The Commission has issued the enclosed Amendment No. 15, Technical Specification Change No. 25 for License No. DPR-38; Amendment No. 15 Technical Specification Change No. 20 for License No. DPR-47; and Amendment No. 12, Technical Specification Change No. 12 for License No. DPR-55, for the Oconee Nuclear Station, Units 1, 2, and 3. These amendments are in response to your request dated November 10, 1975.

These amendments provide Oconee Unit 1 control rod position and operational power imbalance limits for four-pump operation applicable to the period after 245 + 10 Effective Full Power Days of operation.

OCONEE NUCLEAR STATION, UNIT 1

ATTACHMENT TO LICENSE AMENDMENTS

Figure 3.5.2-1A2

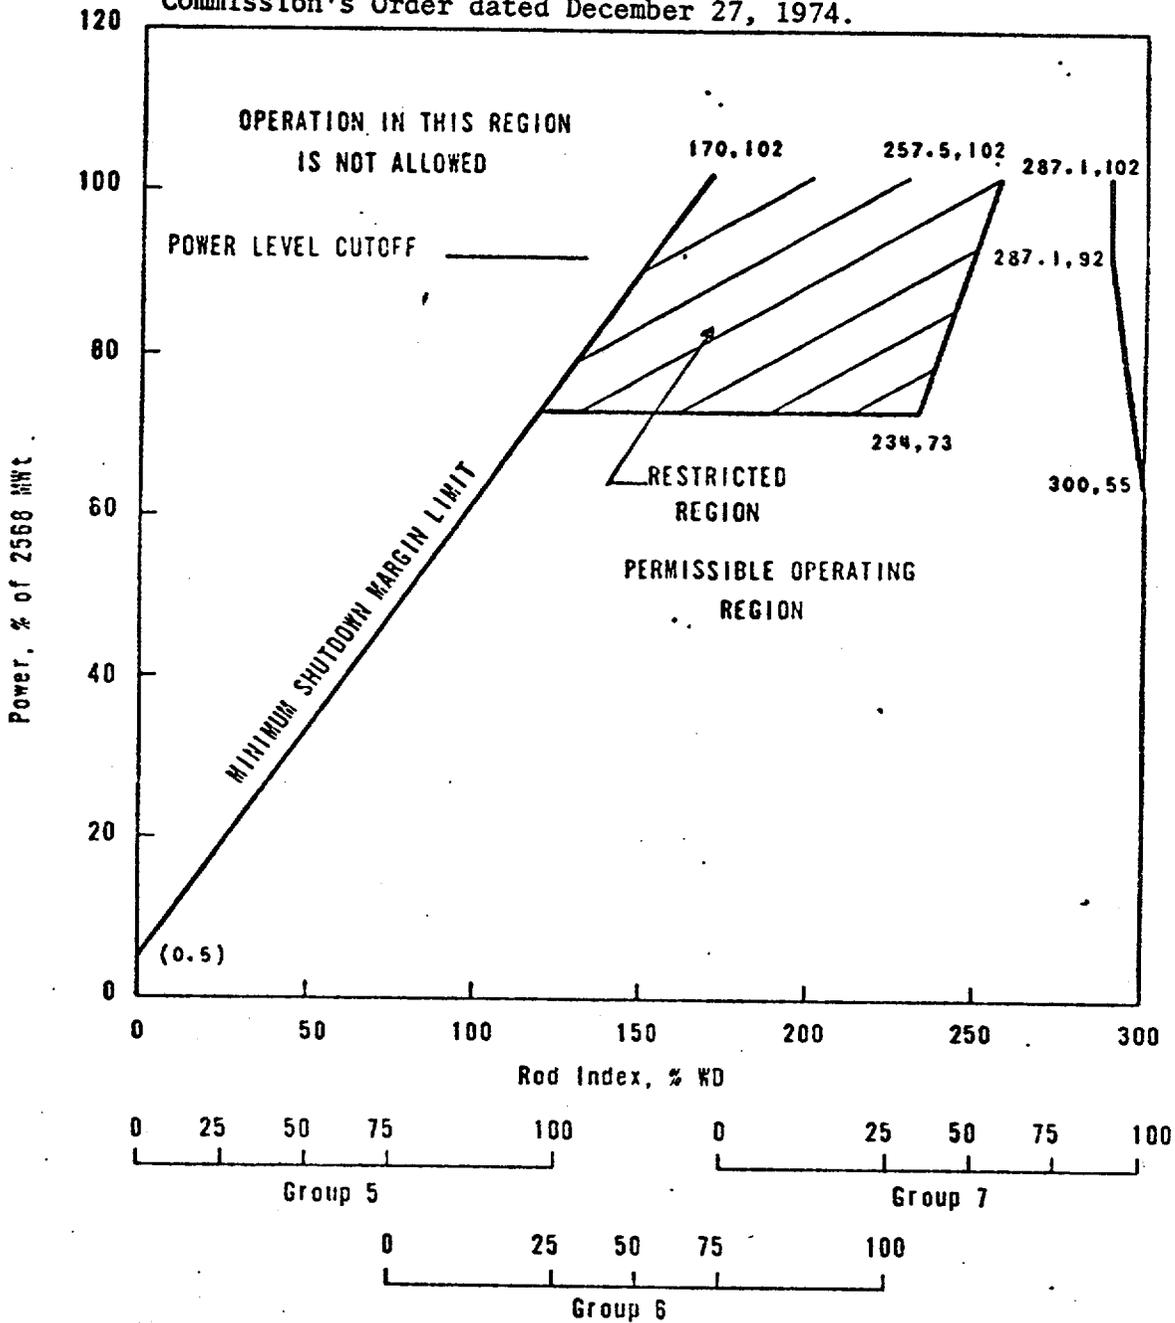
ROD POSITION LIMITS FOR 4 PUMP OPERATION APPLICABLE TO THE PERIOD AFTER 245 ± 10 EFPD, as provided for in the Commission's Order dated December 27, 1974.

Rod index is the percentage sum of the withdrawal of Groups 5, 6 and 7.

Figure 3.5.2-3A

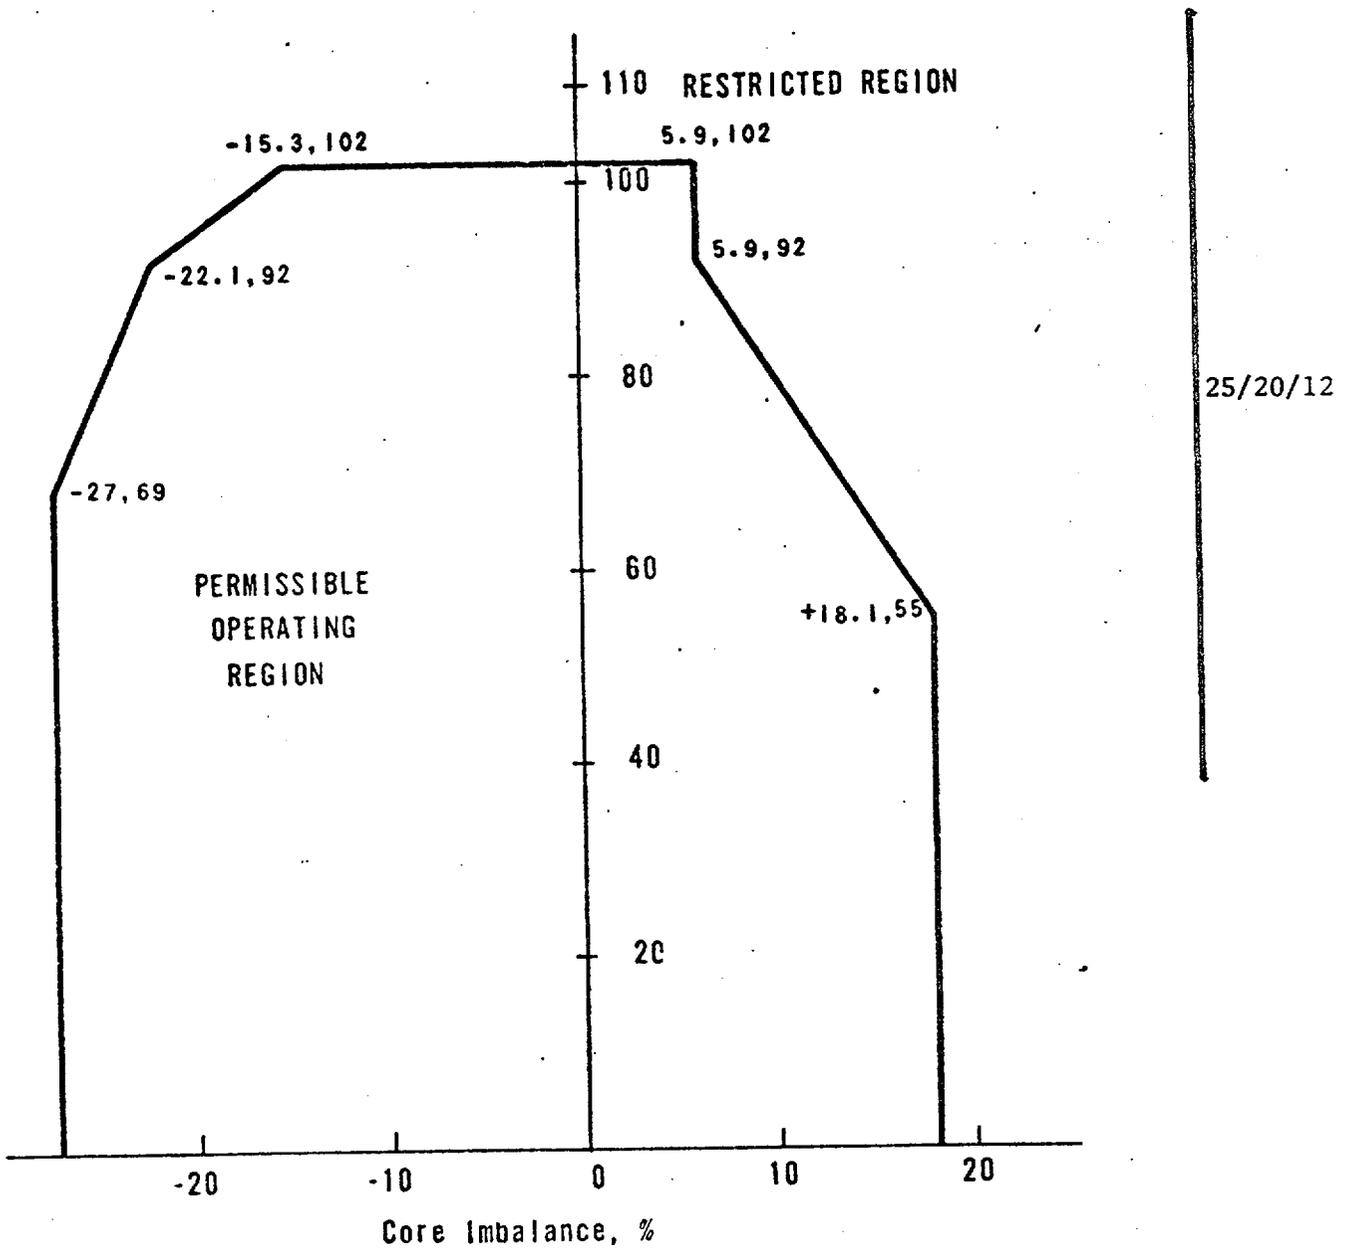
UNIT 1
OPERATIONAL POWER IMBALANCE ENVELOPE
